Draw: FTechworks 2011.5.13

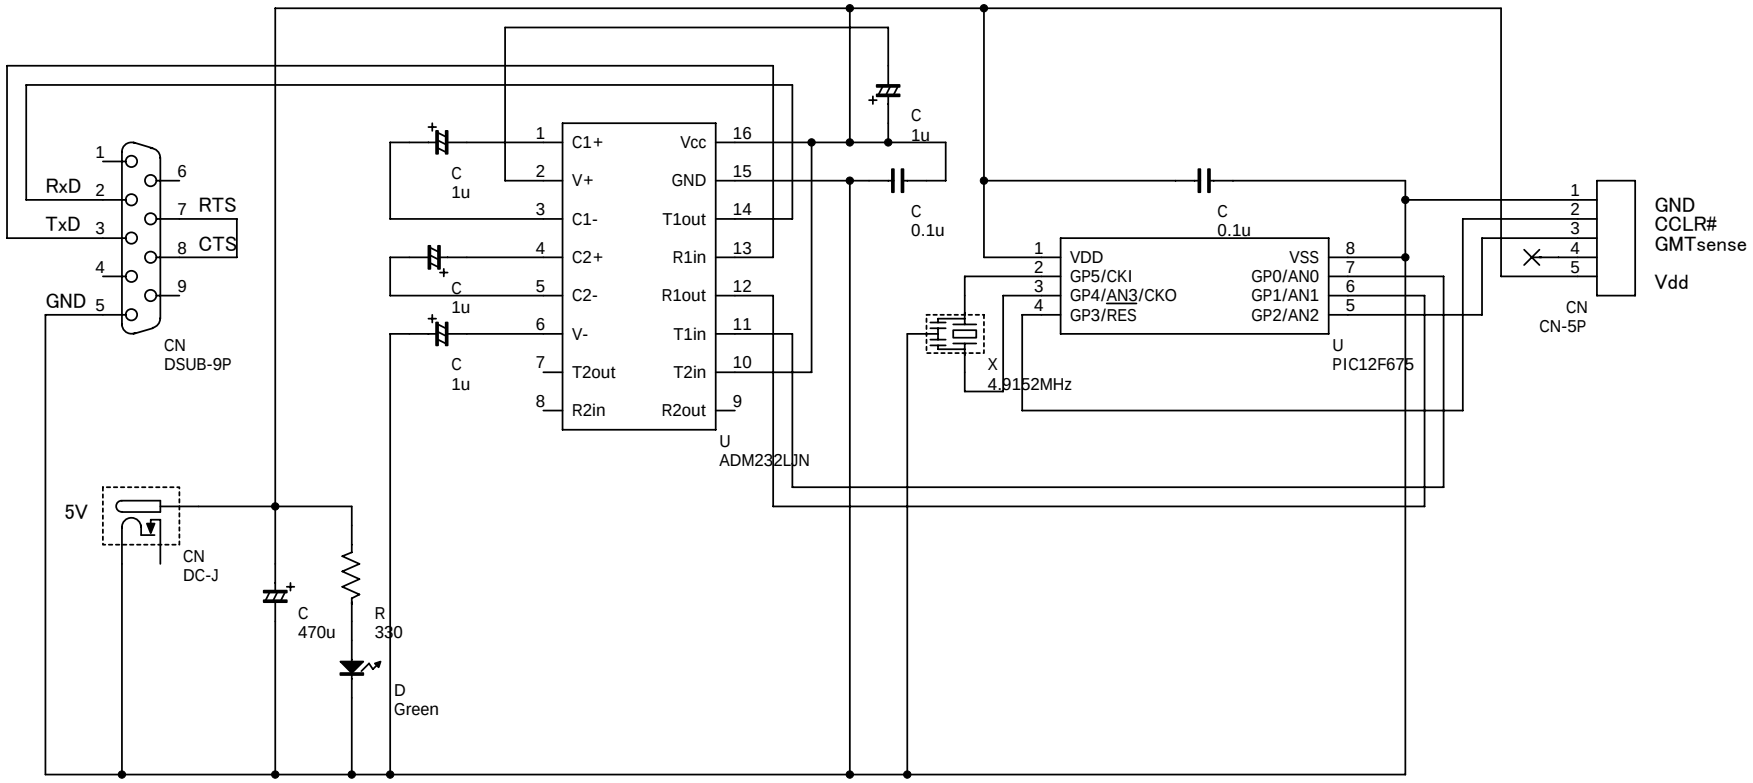
Please pull up CCLR#. PIC12F675 weak pullup is not enough to avoid sensing noise.
GMTsense: Positive edge signal increments count.
Firmware doesn't care TxD to GP1 (receive from host) signal.
